Planning Commission Meeting Agenda
Hartland Township Hall
Thursday, April 25, 2024
7:00 PM

Hartland Township Planning Commission Meeting Agenda Memorandum

Subject: Site Plan PD Application #24-003 Redwood Living Planned Development (PD) Phase II – Preliminary PD Site Plan

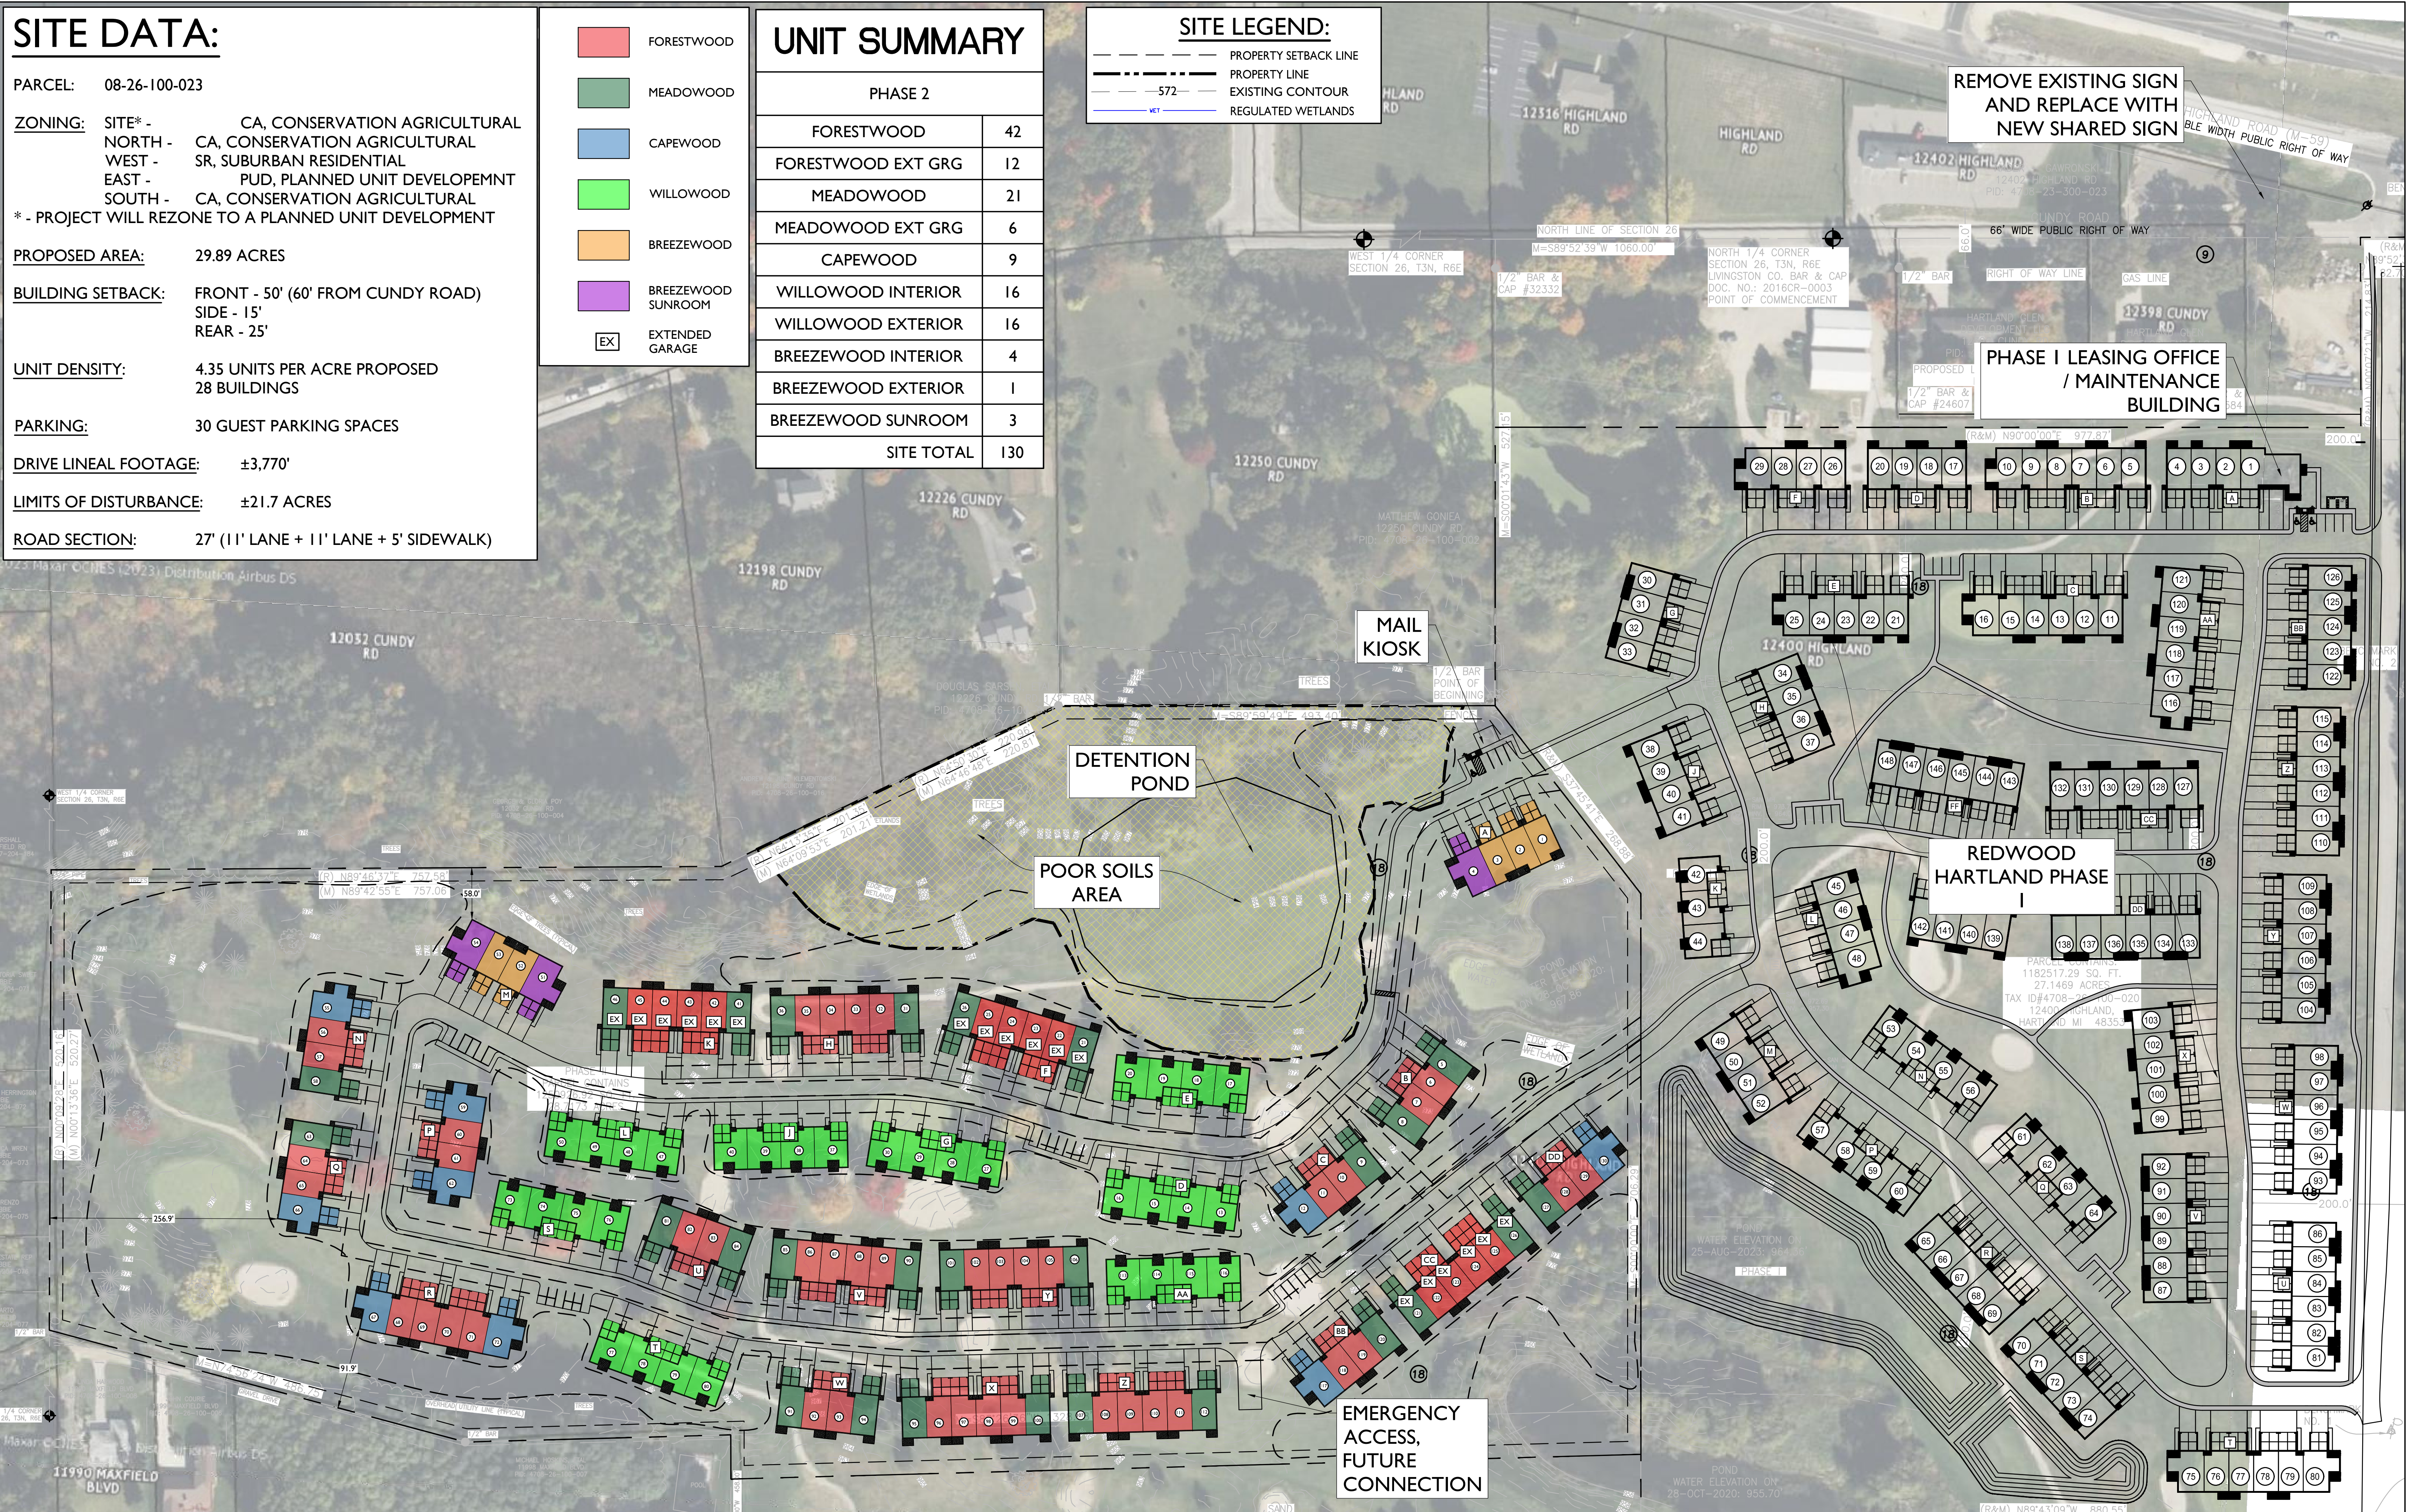
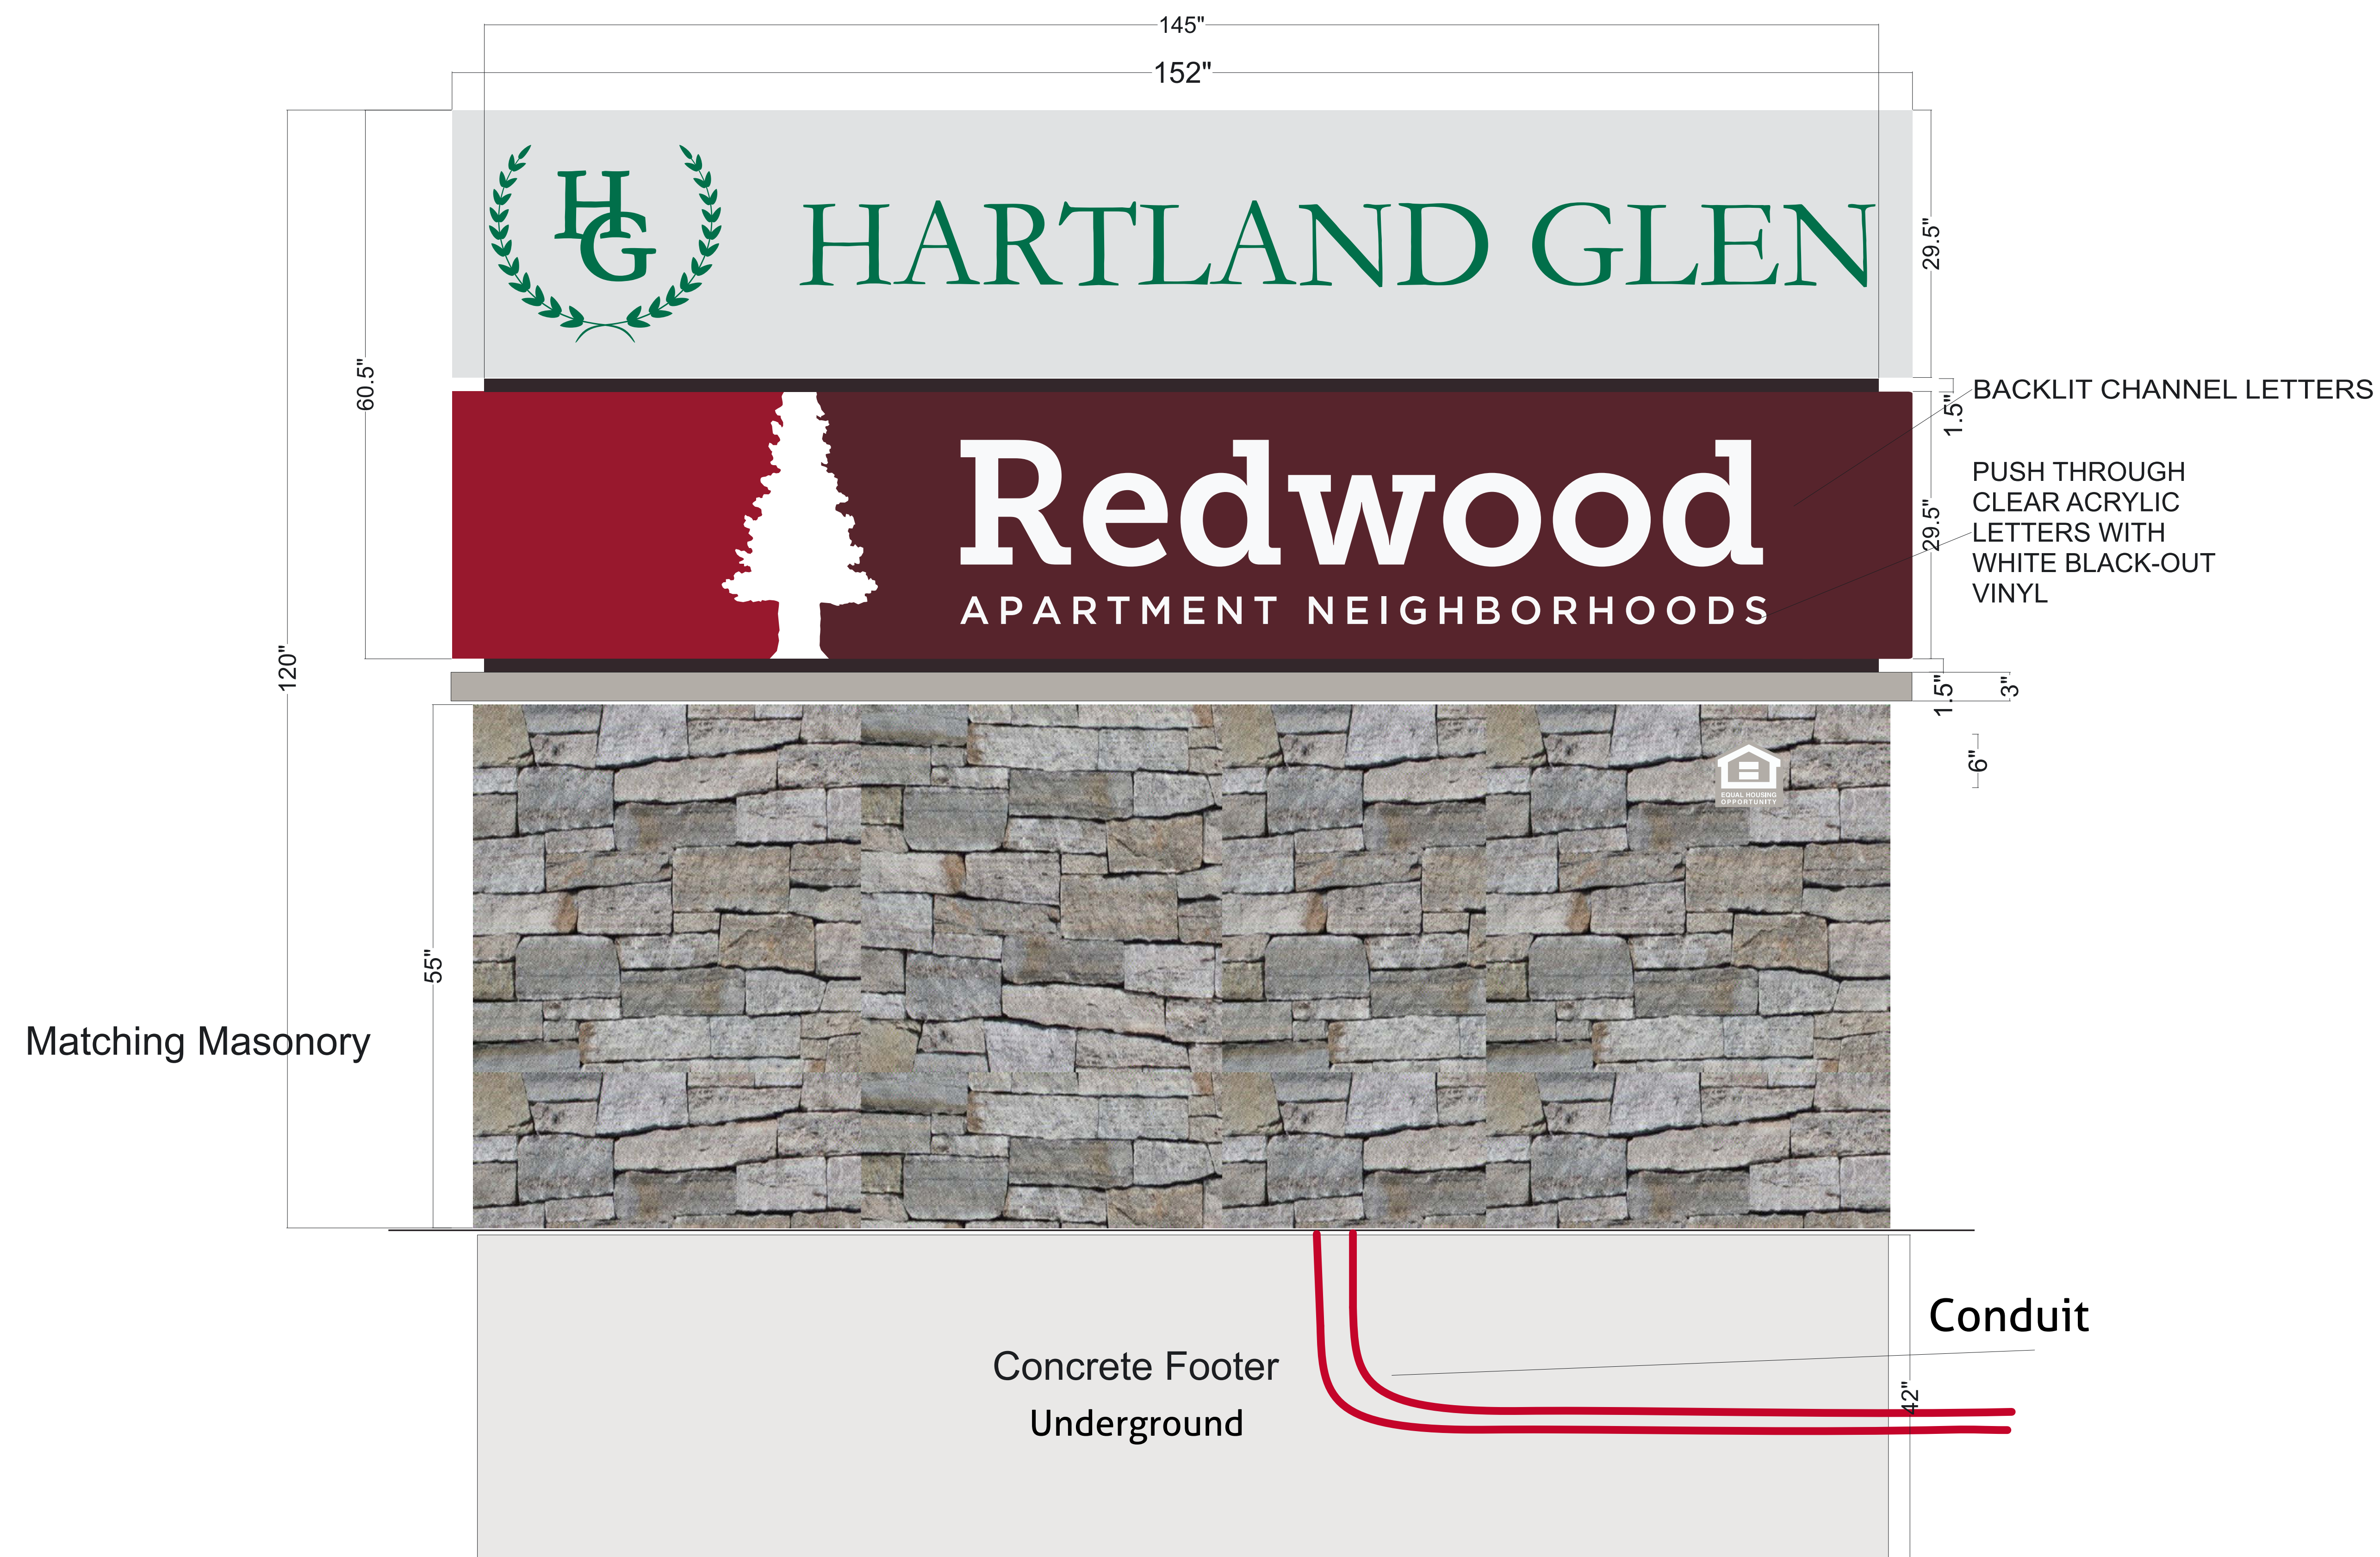
Sheet C200 lists the proposed yard setbacks as follows: front (15) feet, side (15 feet), and rear (15). Sheet C201 shows the south property as a 15-foot side yard. Sheet C202 shows a 15-foot front yard. In order to be consistent with the yard setbacks for Redwood Living Phase I, the setbacks for Phase II should be as follows: front yard setback should be eliminated; rear yard setback of 25 feet should be along the south property line; and side yard setback of 15 feet should be along all other boundaries of the property. The revisions should be shown on the Construction Plan Set.

Per Section 3.1.7 (MDR), the required setbacks are as follows: front yard (30 feet); side yard (10 feet); and rear yard (25 feet). These standards are somewhat difficult to apply in this development as the buildings are not on individual parcels nor are individual building envelopes proposed. Sheet C200 provides proposed dimensional standards for building separation.

2. Drawing C200: Offset distances listed in zoning information on Drawing X100 and in PD regulation table 3.1.18.C.vi.a of the township ordinances are not met. Approval from the planning department will be required for design variance. **Acknowledged. Proposed setbacks are the same distances as phase 1 of the Redwood Hartland PUD immediately adjacent to phase 2.**
